TULSA METROPOLITAN AREA PLANNING COMMISSION

For Meeting No. 2492

September 19, 2007

Walnut Creek Office Park
City of Tulsa, Oklahoma

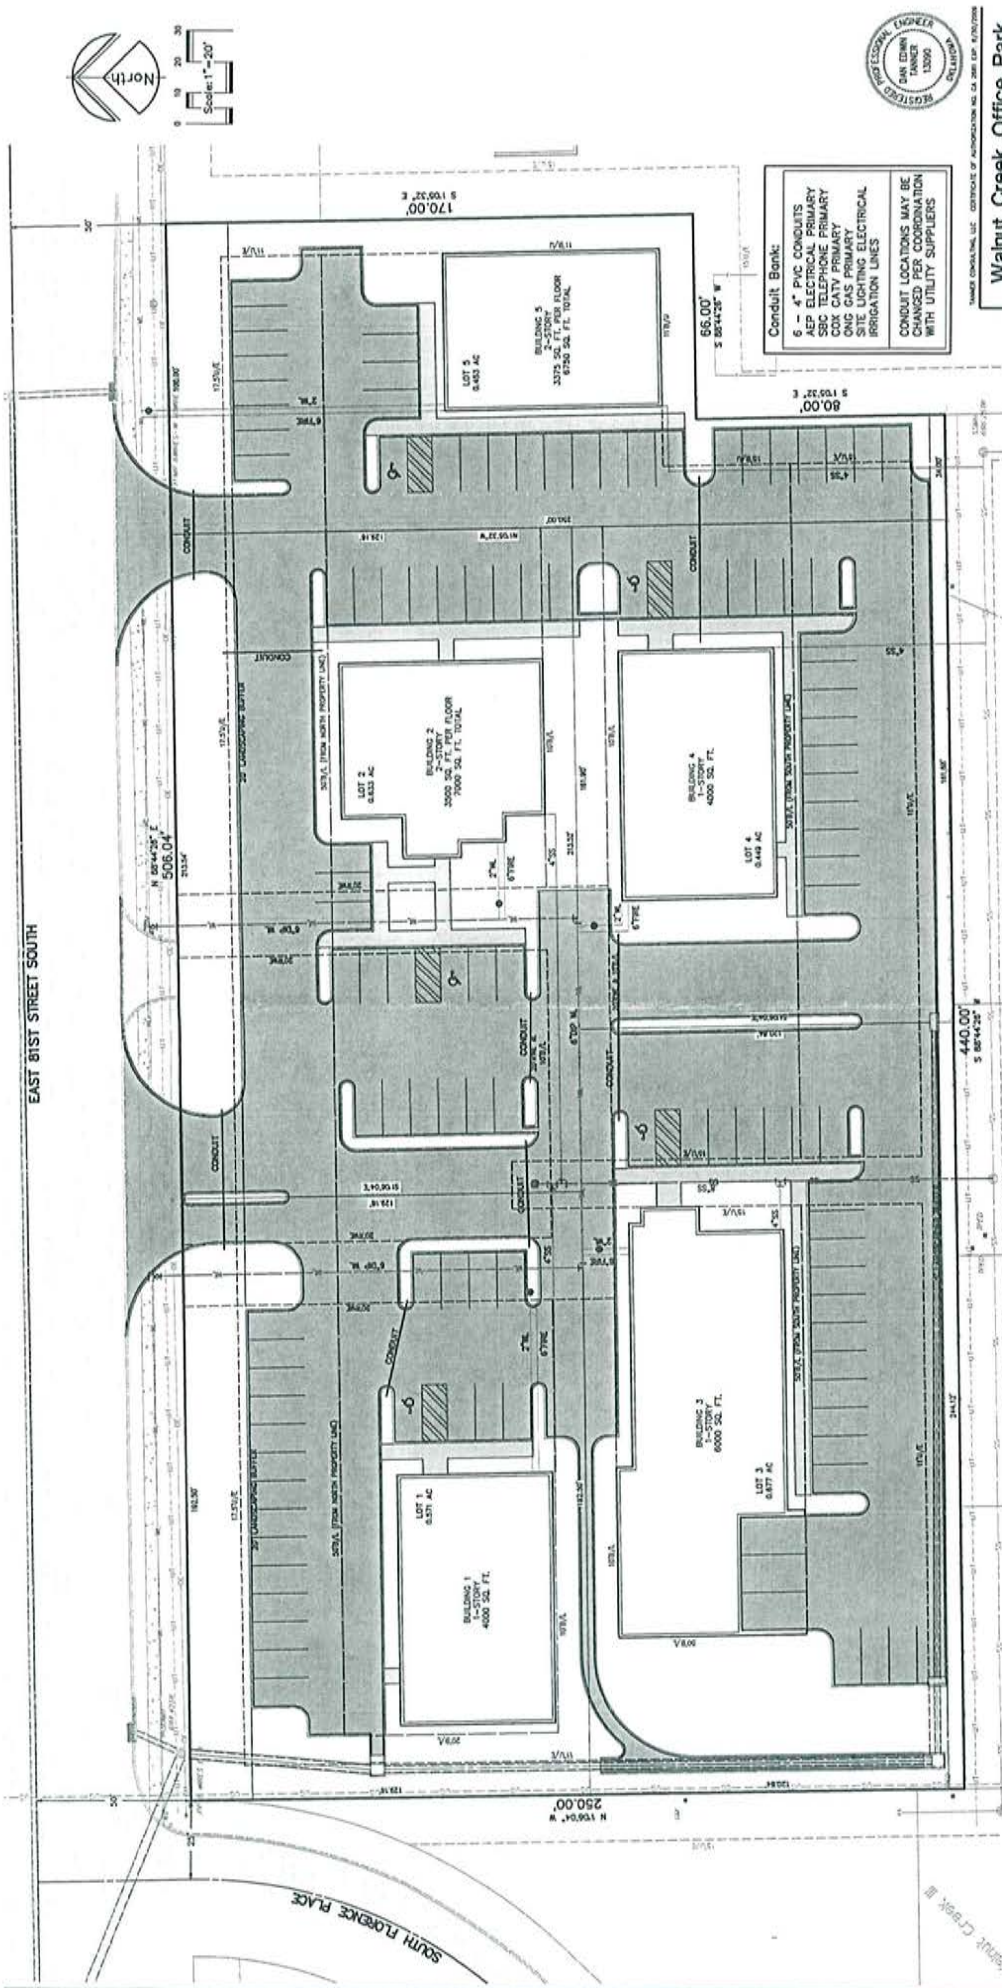
1. **Zoning:** The property is zoned PUD 651(CS, OL, RS-2). All PUD conditions must be met. Show mutual access easements and provide appropriate language in covenants. Show Limits of No Access, especially near Florence Place. Show fence easement and clarify landscape buffer or easement.

2. **Streets:** Section I.A. dedicates right-of-way but none is shown on the plat to be dedicated. Document the Arterial right-of-way. Show both mutual access easements. Change "45 ft Acc." to read "45 foot Access w/Median". Add standard language for an access easement and include the maintenance of the mutual access easements in the owners association. (Section III.A.).

3. **Sewer:** Additional easement will be required to allow a sanitary sewer mainline extension to serve Lot 2. Lots 1,2 and 5 do not have access to the sanitary sewer main for sanitary sewer service. A mainline extension will be required to provide service to those lots.

4. **Water:** Add a 20 foot restrictive water line easement. Add restrictive waterline easement covenants. Show a 6 inch looped water main in a 20 foot restrictive water line easement.

5. **Storm Drainage:** The stormwater pipe along the south and west sides need a drainage easement. Add storm sewer easement language. The connection on the northwest corner in street right-of-way will require PFPI.
